Land East of Newgate Lane East, Fareham

Transport Assessment Addendum

Client: Miller Homes & Bargate Homes

i-Transport Ref: TW/ITB10353-024a

6.3.4 The TA included a Travel Plan which will promote sustainable travel to the future residents and which HCC considers to be of a good standard.

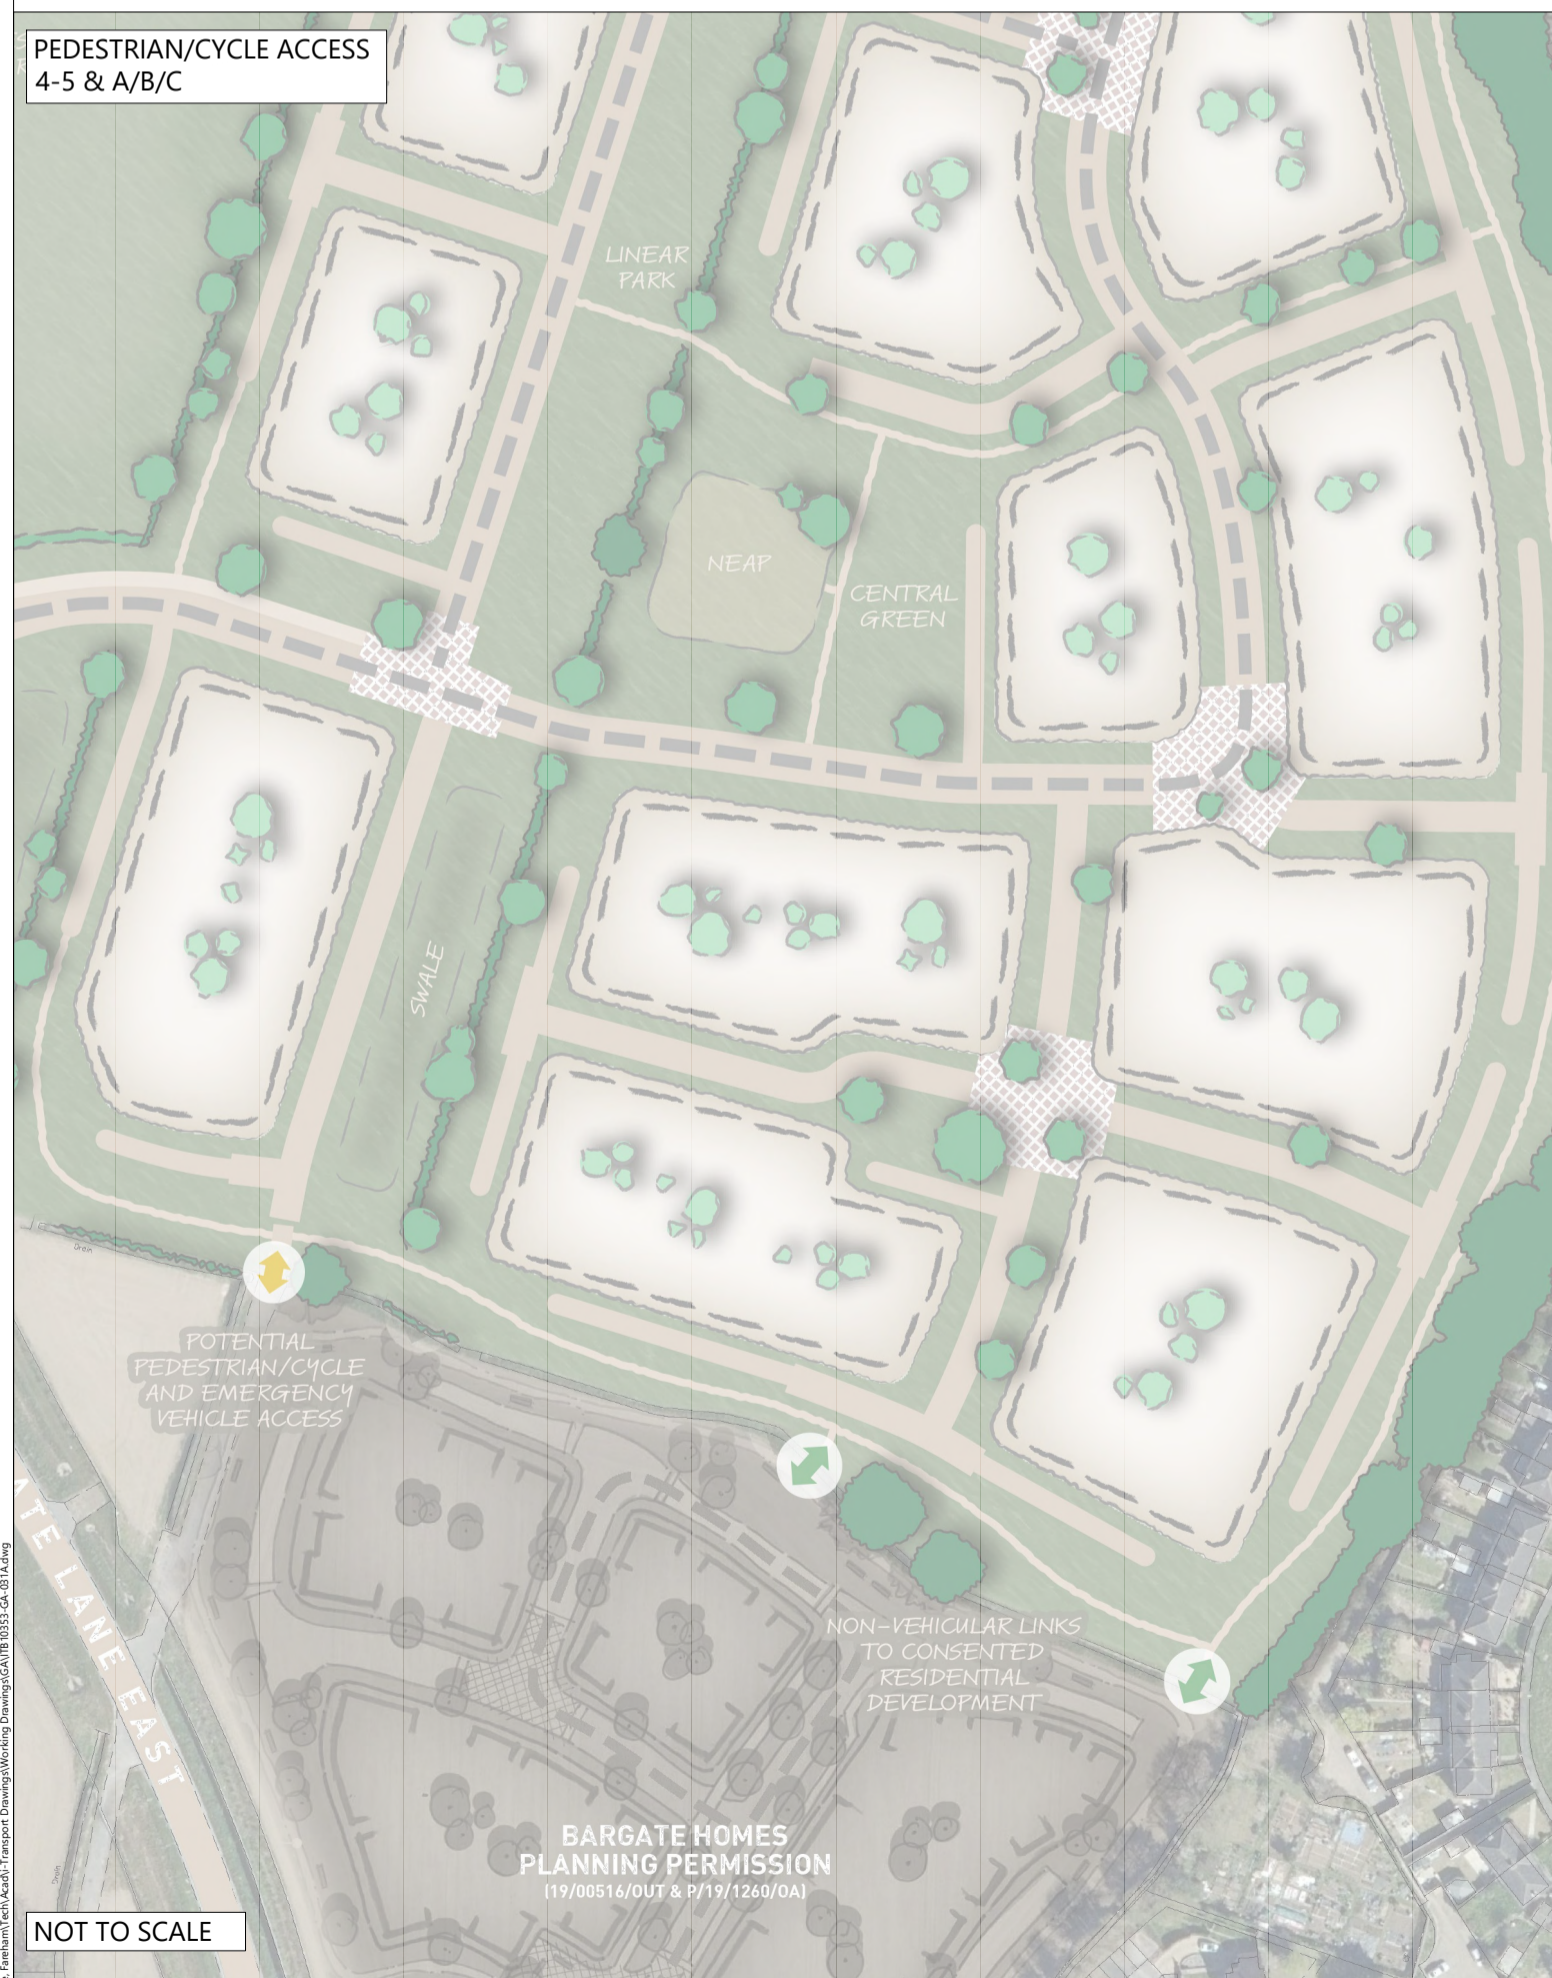
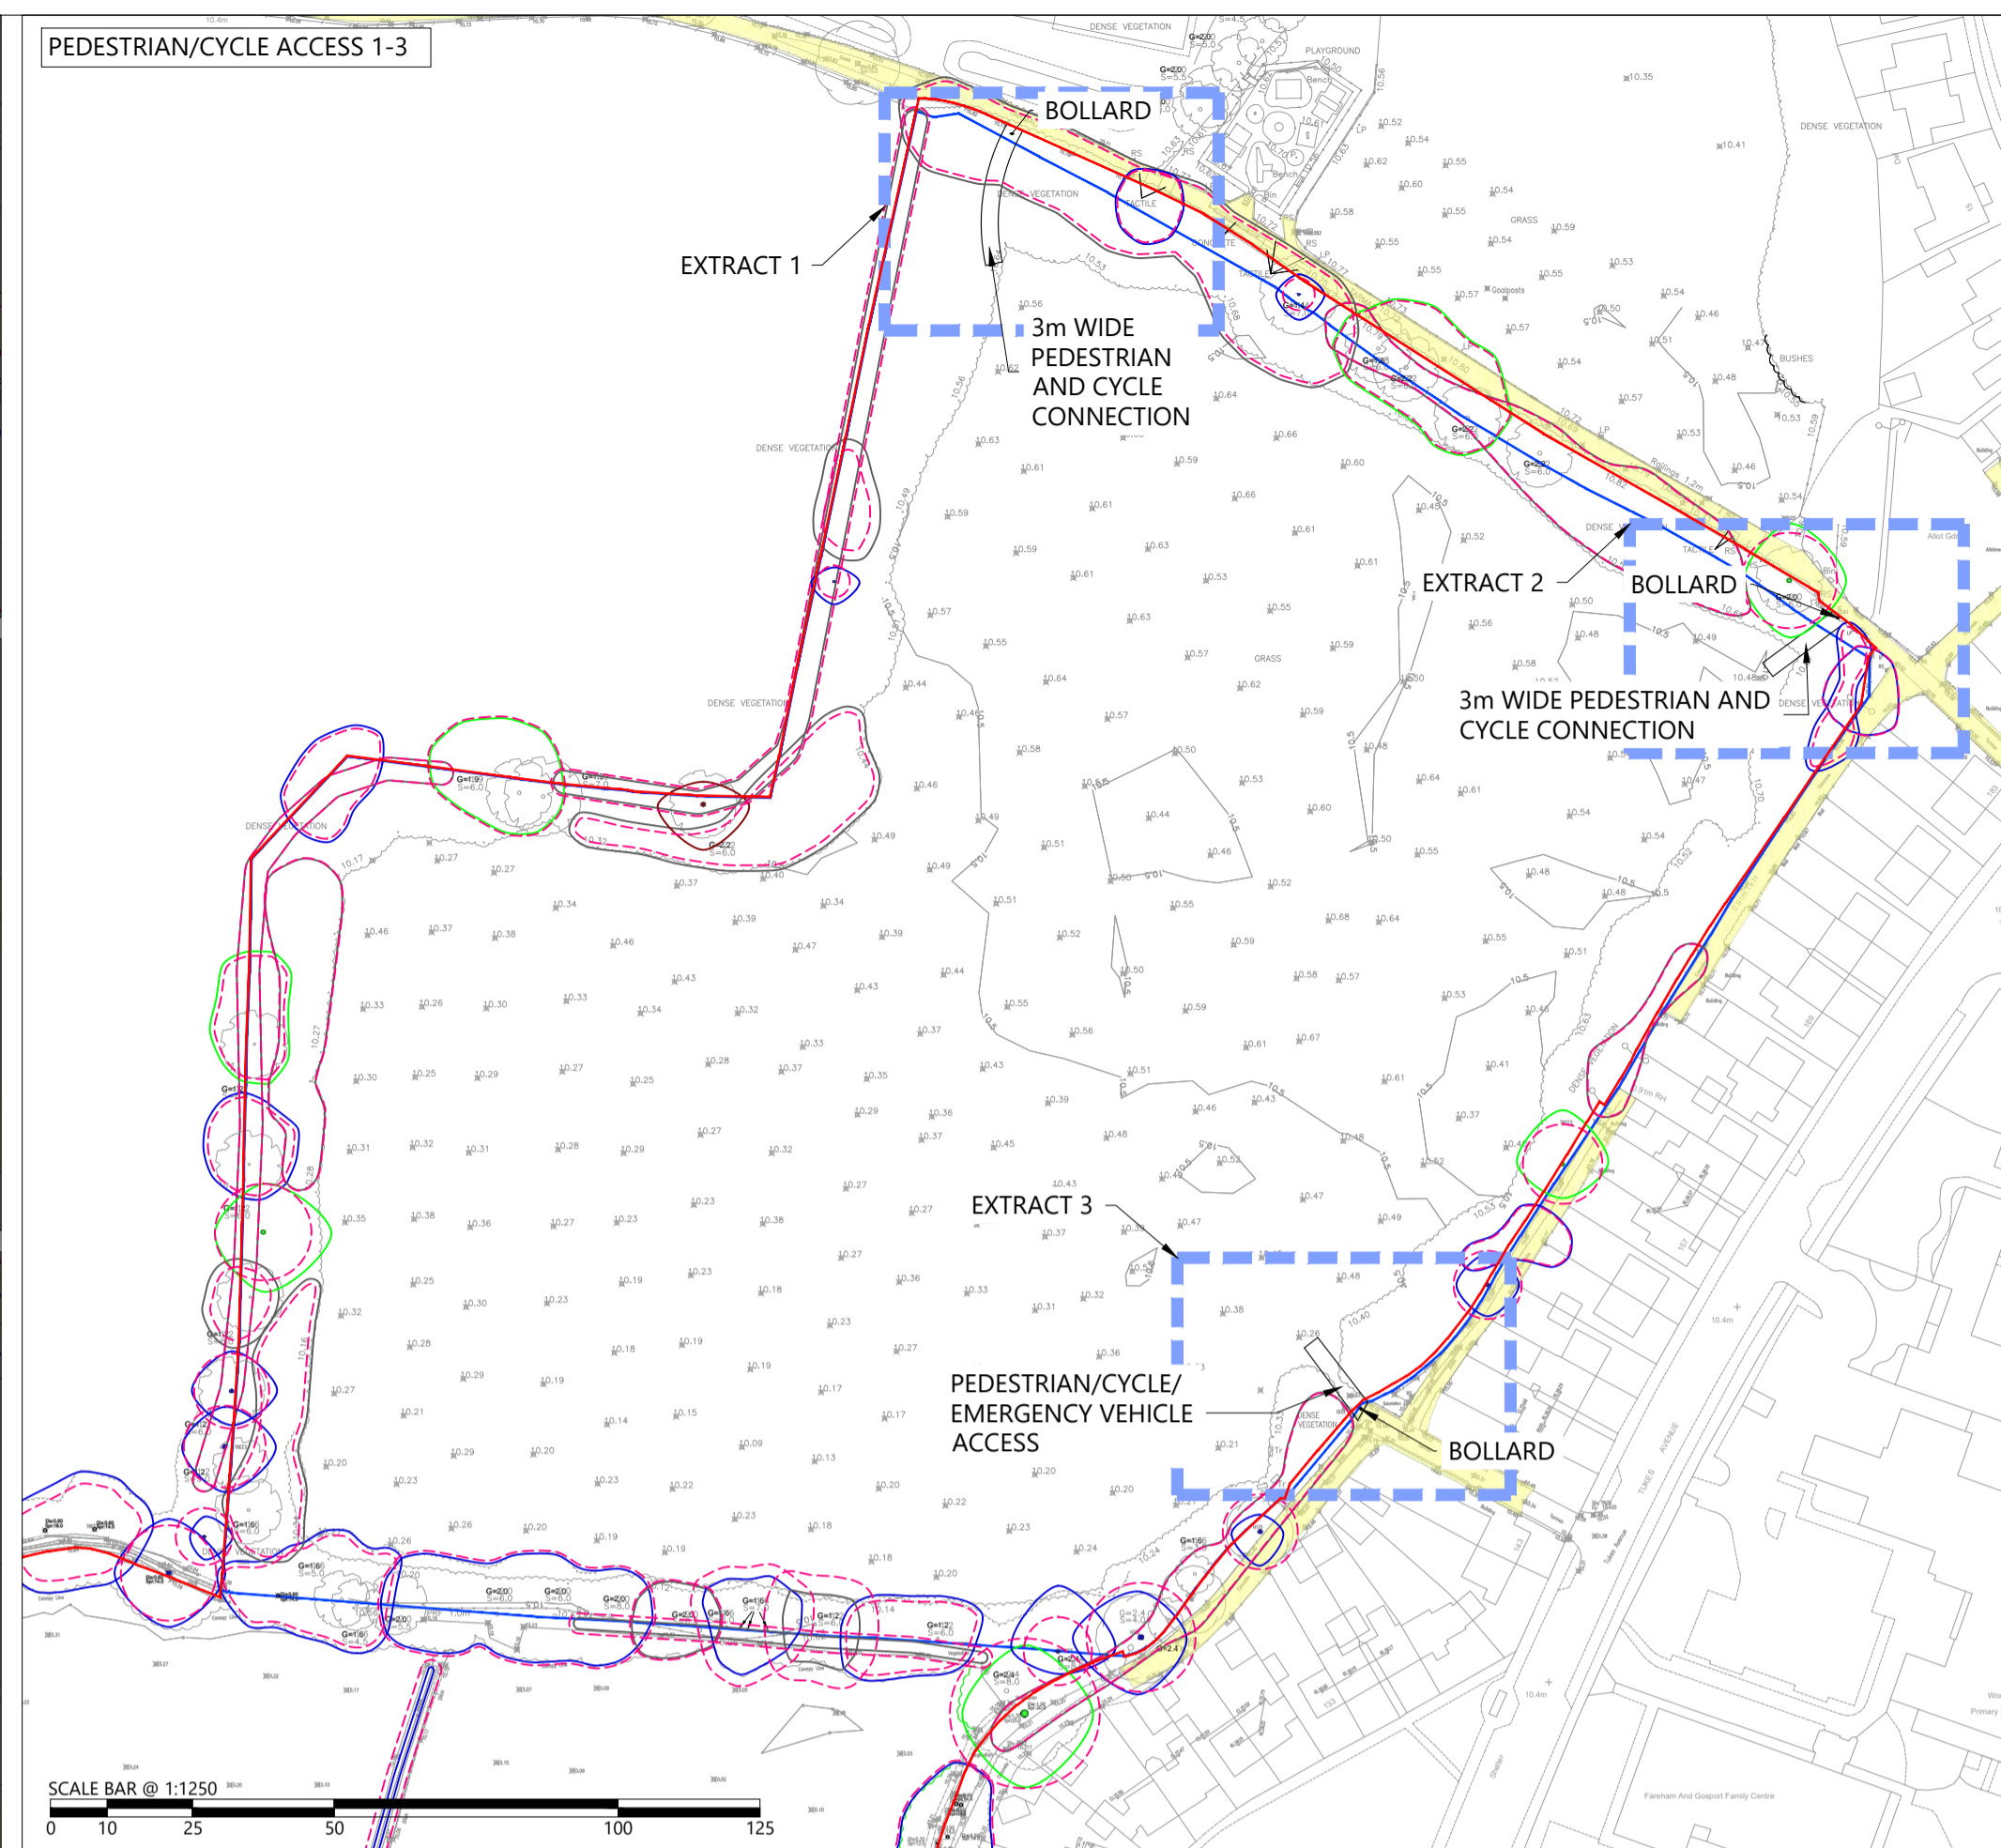
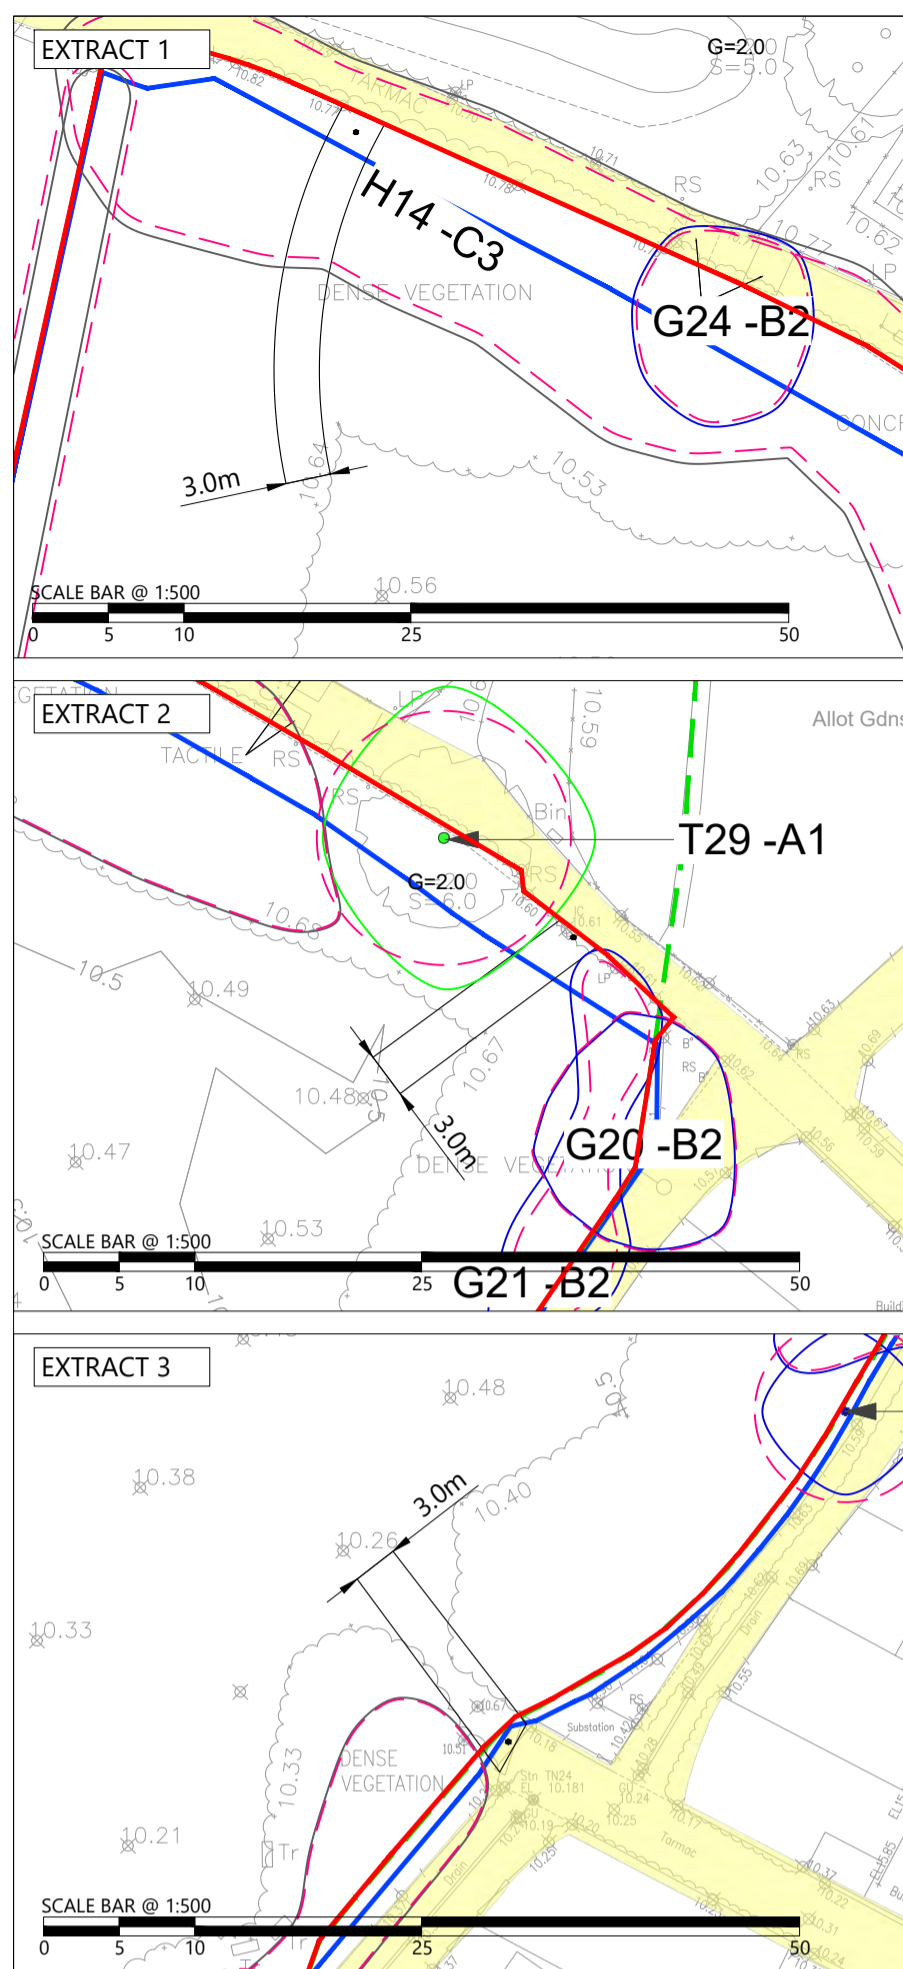
2.4.1 HCC raise various comments in relation to each of the proposed arrangements for pedestrian and cycle access (as depicted on TA **Drawing ITB1053-GA-031A**). These are addressed in turn.

2.4.27 Taking the active travel access strategy comprehensively (**Drawing ITB10353-GA-031 A**), there is little justification to upgrade Access Point 6 for cycle usage, which would require upgrading of the associated crossing of Newgate Lane East. There are six proposed cycle connections serving the site, provided in all directions, with two to the south at the eastern and western corners of the site, two to the north, again at the eastern and western boundaries, to the east (to Tukes Avenue) and to the west at the proposed access roundabout. This ensures high-levels of permeability specifically to prioritise pedestrians and cyclists.
